WCAP-9561-NP-A

Addendum 2

ADDENDUM TO
BART-A1: A COMPUTER CODE
FOR THE BEST ESTIMATE ANALYSIS
OF REFLOOD TRANSIENTS
(SPECIAL REPORT: NS-NRC-85-3025-A)

SUBJECT: ACCEPTANCE FOR REFERENCING OF SPECIAL REPORT NS-NRC-85-3025 (NP),
"BART-WREFLOOD INPIIT REVISION"

COMPARISON OF INTEGRATED CORE INLET FLOW
FIGURE 2

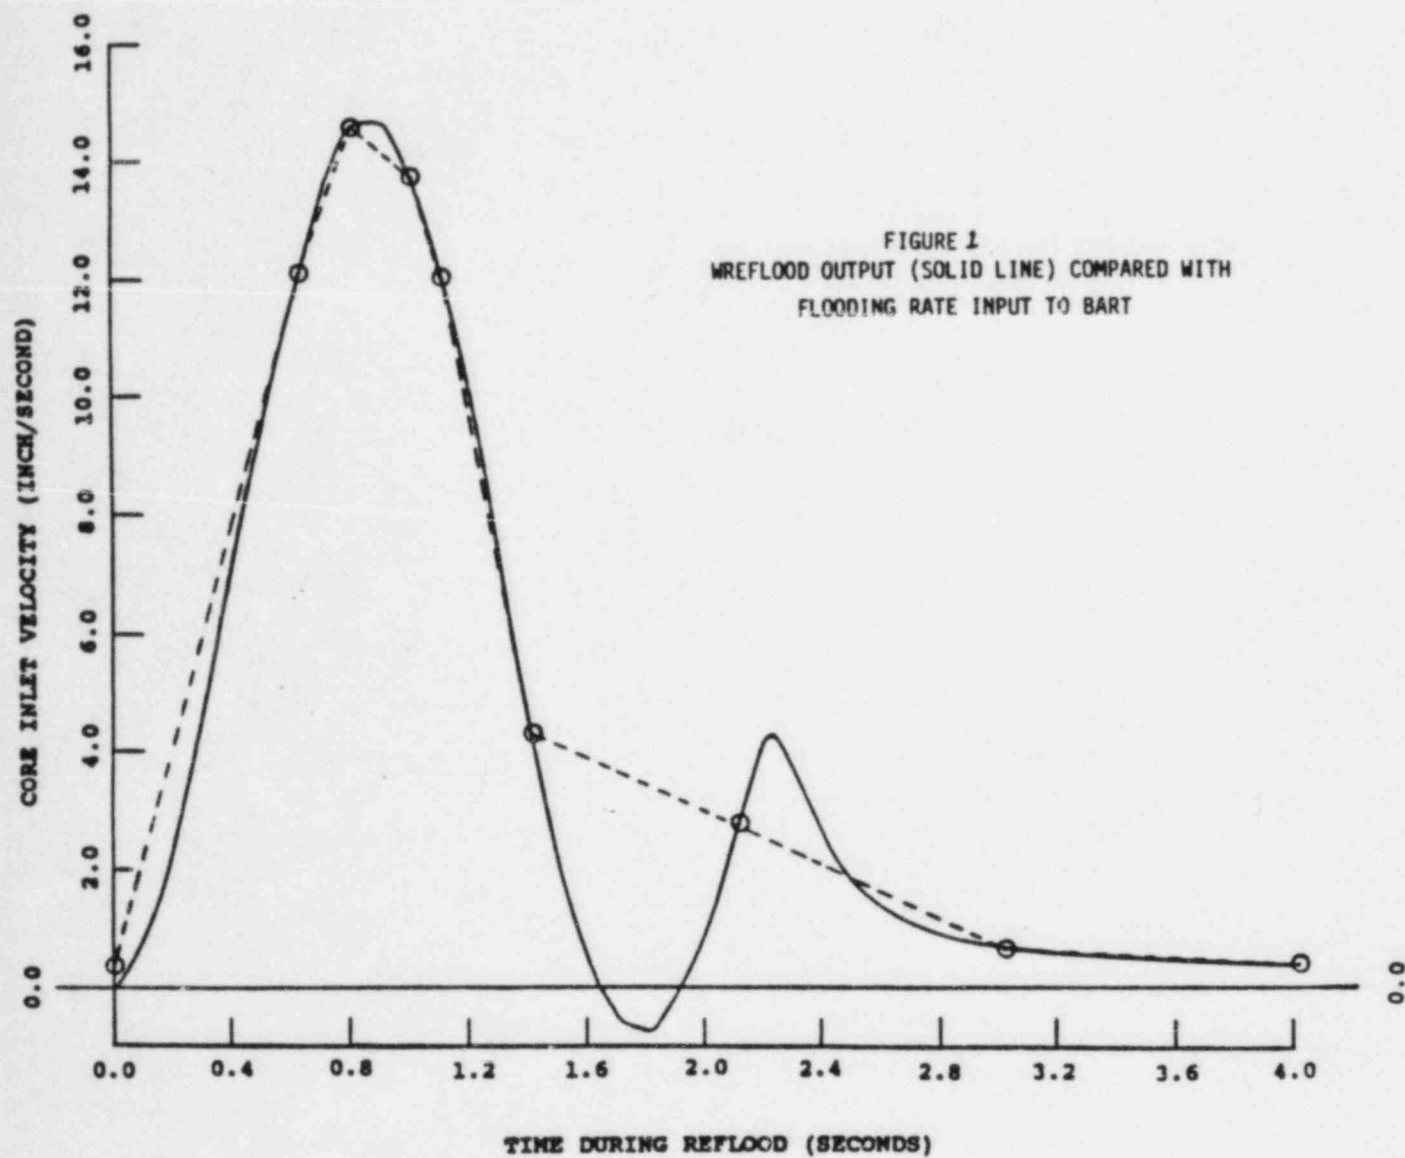
A limited number of instantaneous values of Vin are available to the analyst for replicating the Vin curve as a part of the BART input. Use of all available Vin values in the initial surge portion of the transient does not necessarily produce good integrated agreement at the start of the second portion of the transient. Connecting the discrete input points can result in more water in the core than the WREFLOOD code calculates.

As a result the integrated value of water in the core may be higher in BART than in the WREFLOOD code. This higher water level provides an earlier onset of entrainment which results in an earlier initiation of steam cooling in the upper regions of the core. This earlier initiation of steam cooling gives a lower calculated PCT than would be calculated if the integrated value of the Vin curve from WREFLOOD had been matched exactly.

The WREFLOOD integrated Vin curve and the BART integrated Vin curve for a representative plant are presented in figure 2.

A data transfer procedure, utilizing the available WREFLOOD Vin output, has been developed and implemented that results in good agreement between the WREFLOOD calculated value of the integrated flooding rate and the BART calculated value of the integrated flooding rate. This procedure also cautions the analysis reviewer to verify the similarity of the integrated Vin curves between the two codes and provides a standard method for comparing the two curves.

A reanalysis of the Turkey Point Units 3 and 4 was performed using this new methodology. The results of this reanalysis indicated that the calculated PCT increased 79 F to 2051 F from the original analysis value of 1972 F.
